DOCUMENTATION TRANSMITTAL

Documentation Description: Nonconformance Report - 5063-HV

NONCONFORMANCE REPORT

1. PROJECT NAME Midland Nuclear Plant Units 1 and 2		JOB NO. - 7220		19. NO. 5063	20. PAGE 1 OF 8
2. UNIT(S) Z	3. DRAWING/PART NO. 2-634-4-2	REV Sub Rev 3	4. ITEM DESCRIPTION Spring Can Assembly (See Block 10)	5. ITEM LOCATION Aux Bldg E1594'10"

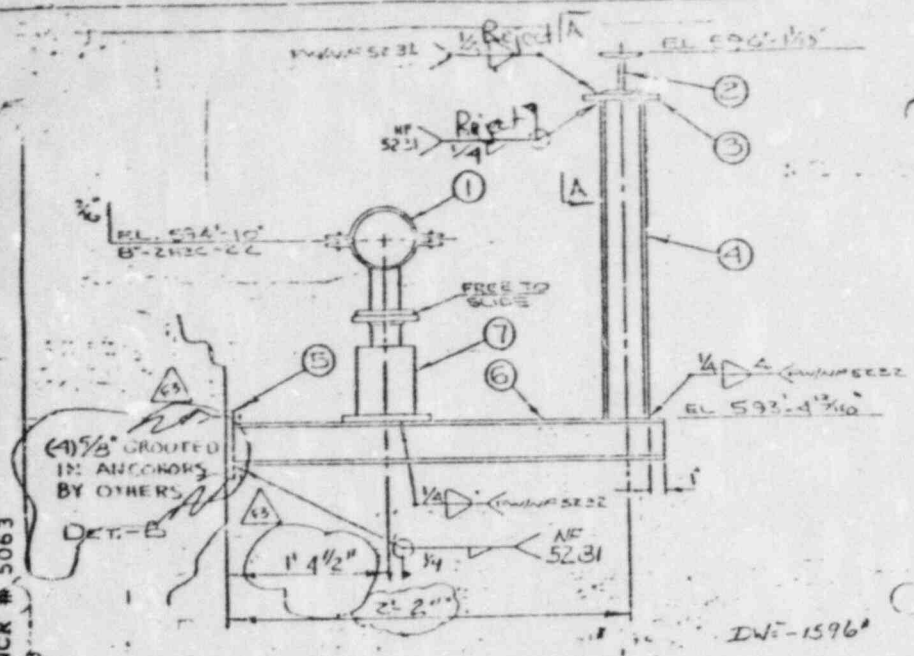
shall not exceed 1/2") " No undersize condition is acceptable for width or length " contrary to the above an undersized fillet and undercut > 1/32" exists on the weld for Items # 4 to 3, the ends of the welds for Items # 3 to # 2 are undersized, the east side of the weld for the struction to the pipe clamp on Item # 1 is undersized.

PACI P.2.30 states in part: "locking devices... all threaded connections, except high-strength bolts shall be secured by one of the following methods: Jam nut with hex nut, two jam nuts, pin or cotter, tack weld, C-clip, standard staking method for thread locking. Contrary to the above 4 grouted anchor bolts on this support are not secured by any of the methods stated above.

C-305 8/6 Para. 4.17 states in part: "When expansion anchors... are located... near a grouted anchor the minimum center to center spacing shall be the sum of the minimum edge distances of both anchors..." Contrary to the above a 1/2" abandoned expansion anchor is installed with all threads intact 5" from the upper right 5/8" grouted anchor and 5 3/4" from the upper ~~right~~ ^{left} 5/8" grouted anchor - the required center to center is 6 3/4".

NCR-2409 was written against anchors (expansion type) on 2-634-4-2 - the disposition requires that the expansion anchors be removed and grouted anchors to be installed. Condition a hole is required 3 1/2" to the right of the upper right grouted bolt, the lower right bolt also has two repaired holes one 2 1/2" to the right and 3 1/2" below. The edge distance requirement is 3 3/4" for a 5/8" anchor. No documentation exists for the repaired holes.

REFLECTS THE DESCRIBED CONDITION IN BLOCK 16. NO IMPACT ON QUA TEST OR CALCULATION DRAWING SHALL BE REVISED ^{IN ACCORDANCE WITH} PER PROJECT ENGINEERING PROCEDURE 4-62.1.

ITEM #6 - PROJECT ENGINEERING DOES NOT CONCUR WITH THE FIELD ENGINEERING DISPOSITION TO 'USE AS IS'. FIELD ENGINEERING TO REWORK AND PROVIDE DOCUMENTATION FOR THE REPAIRED HOLES IN ACCORDANCE WITH SPEC 7220-C-305 (Q) PARA. B.2.2. NO IMPACT ON CALCULATION OR QUA TEST. NO DRAWING REVISION REQUIRED. ^{REV 8/10/13} WATER 6/26/13

Plate of Item 1

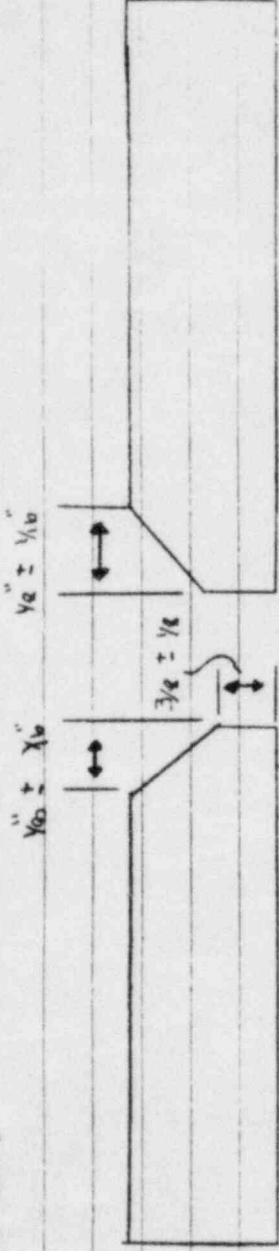
Full contact is maintained between the plate of Item 1 and the spring.

The identification of Item 2 measures ($3/2$ " x $3/12$ " x $3/4$ " deep) \pm $1/32$ for the measurements.

Field engineering recommends Use Co do for items 1 & 2.

23. PROJECT ENGINEERING DISPOSITION ITEM #2 - PROJECT ENGINEERING CONCURS WITH THE FIELD ENGINEERING RECOMMENDED DISPOSITION TO 'USE AS IS'. WHERE AS INDENTATION DOES NOT EFFECT THE INTEGRITY OF THE SUPPORT OR VIOLATE GRINNELL QA/QC PROCEDURE OZAD01. NO IMPACT ON CALCULATION OR QUAL TEST. NO DRAWING REVISION REQUIRED. ITEM #2 #1 - PROJECT ENGINEERING CONCURS WITH THE FIELD ENGINEERING RECOMMENDED DISPOSITION TO 'USE AS IS'. WHERE AS PCNM-10761 HAS BEEN DISPOSITIONED APPROVED (7-23-83), AND (P2/4)

CUSTOMER: CONSTRUCTION CO.
 ORDER OR CONTRACT NO. P.O. 77-20-E-105-AC
 JOB NAME: HUBBARD 1 & 2 BR. VENT.
 DRAWING NO. _____
 SKETCH NO. 7-634-4-2

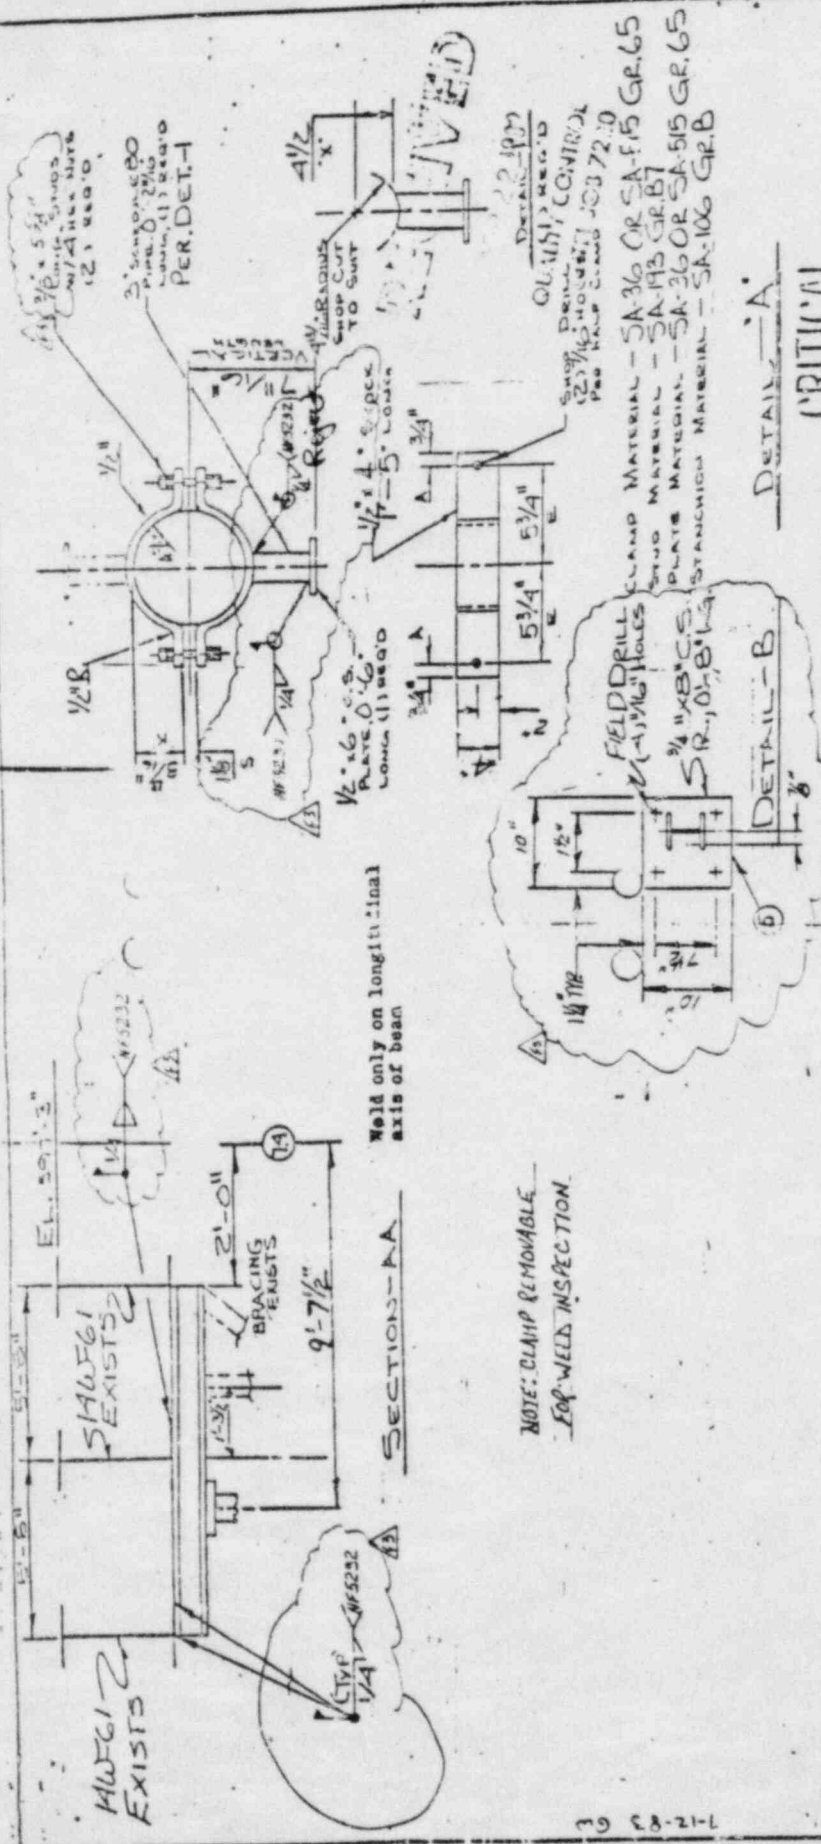
Number 3 - Reweld the welds from items 4 to 3 and from items 3 to 2, ~~the weld from the attachment to the pipe clamp is not a full-strength condition. The amount of weld agrees with the drawing.~~

Number 4 - Reweld, grouted anchor bolts to be secured with double nuts.

Number 5 - Reweld, Abandoned anchor to be removed and replaced with grout in accordance with specification 7220-E-305.

Number 6 - Field Engineering recommends to Use Co do.

ITEM 3 (Weld joining stanchions to pipe clamp) USA AS 15 - Existing weld size meets $\frac{3}{16}$ " fillet requirement but less than $\frac{1}{4}$ " fillet size called for on DWG 2-634-4-2 AWS sub 5/F3 and 2 of 2. Existing field condition will not allow any more filler metal. The outside edge of clamp is slightly rolled inward not allowing DWG. required weld size. See below note: Rolling caused by binding of plate for clamp R/R 2/25/84

ITEM 5 Remark - Abandoned anchors shall be removed. Holds shall be removed in accordance with Spec C-231.

ITEM 6 Remark - Removed Grout from existing retained holes and repair in accordance with C-231. Quality Control to provide Quality Documentation.
